DOCKET 50-255, LICENSE DPR-20 -
PALISADES PLANT - CORRECTIONS TO ALLOWABLE
TUBE WALL DEGRADATION ANALYSIS

Our letter of February 12, 1976 transmitted a request titled "Analysis To Determine Allowable Tube Wall Degradation for Palisades Steam Generators." Following submission of this report, a number of errors have been observed.

ANALYSIS TO DETERMINE
ALLOWABLE TUBE WALL DEGRADATION
FOR
PALISADES STEAM GENERATORS

Revision 1, March 5, 1976

FIGURE B.4: FLUID FORCES ACTING ON TUBE

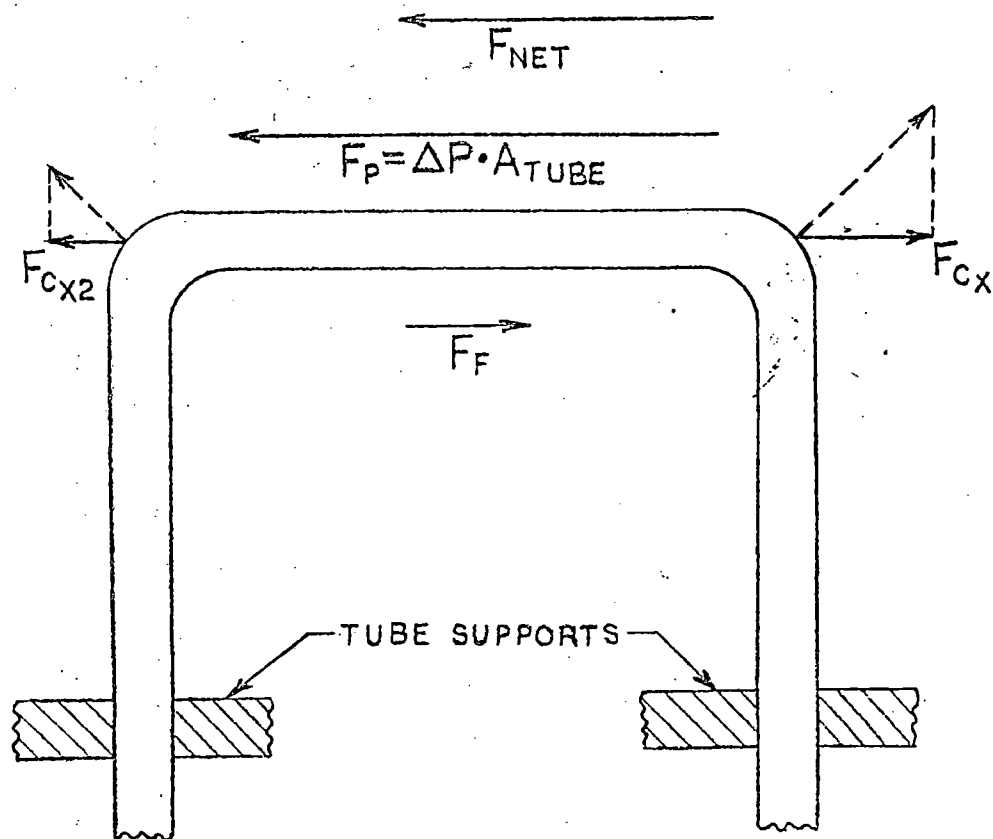
Title Page
Sheet 5
Sheet 6
Figure A.5
Figure A.6
Figure A.20
Figure B.4
Figure B.5

The border has been marked where changes were made and the corrected pages are attached.

$$F_{NET} = F_P - F_F - (F_{CX1} - F_{CX2})$$

$$F_{NET} = 60.8 - 3.5 - 1.2 = 56.1 \text{ LBF.}$$
